Product / Process Change Notification (PCN)

| PCN Number: PCN_IndDD_20241129 Affected Series: WE-DD Affected Order Codes: See table 1 for list of affected order codes PCN Date: 2024-08-29 (YYYY-MM-DD) Effective Date: 2024-11-29 (YYYY-MM-DD) | Change Category: <input type="checkbox"/> Equipment/Location <input checked="" type="checkbox"/> General Data <input type="checkbox"/> Material <input type="checkbox"/> Process <input type="checkbox"/> Product Design <input type="checkbox"/> Shipping/Packaging <input type="checkbox"/> Supplier <input type="checkbox"/> Software |

Table 2: Update of product drawing

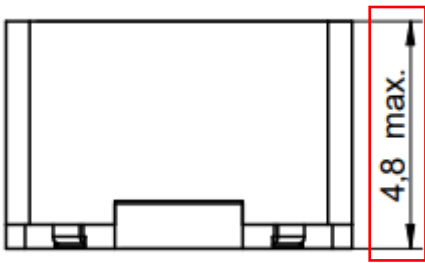
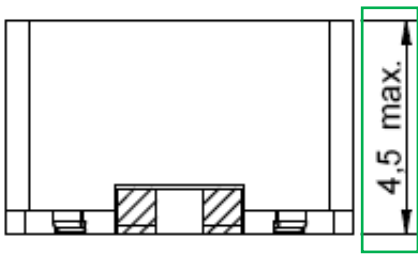
The start of winding (SOW) circle will be included in the product drawing as shown in Table 3.

| Before Change | After Change |
|--|--|
| <p>The original drawing doesn't have a circle to indicate SOW.</p>  | <p>The correction consists of a circle to indicate SOW.</p>  |

Table 2: Change in product dimension

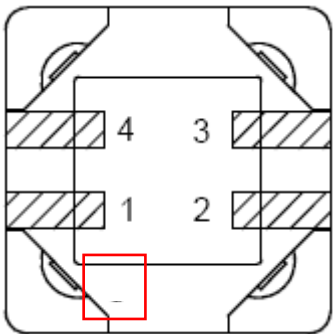
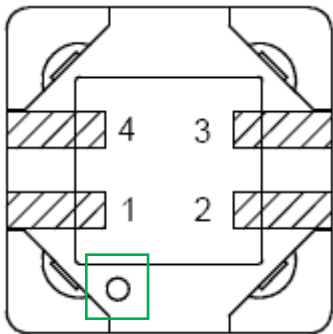
The height of the product will be corrected in the datasheets and can be observed in Table 2.

| Before Change | After Change |
|---|--|
| <p>The original drawing had the wrong height.</p>  | <p>The correction consists of the modification of the height.</p>  |
